District Security Upgrades And Additions

Question and Responses

October 25, 2023

Additional electronic strike needed

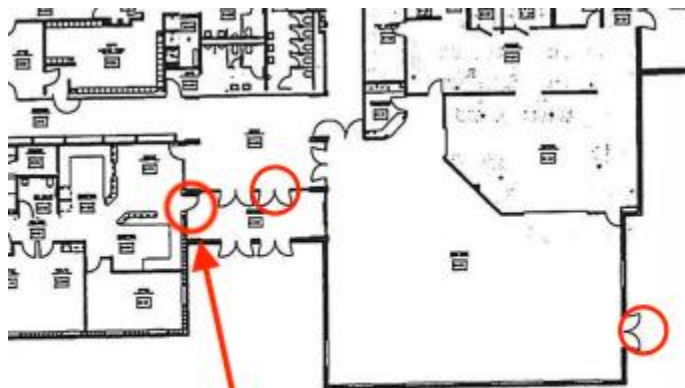
Q17-[DOOR CAMERA SYSTEMS & ACCESS CONTROL SYSTEMS, READERS, ETC.]-Can you clarify the location of the doors requiring electronic strikes within the RMS entryway?

R17-RMS-MAP-3 correctly specifies where the door camera systems are to be installed. An electronic strike will need to be installed on the west location as that is not present. That was erroneously left off of RMS-MAP-1 and will be the responsibility of the winning vendor of the “Access Control Systems, Reader, Etc.” section of the RFP.
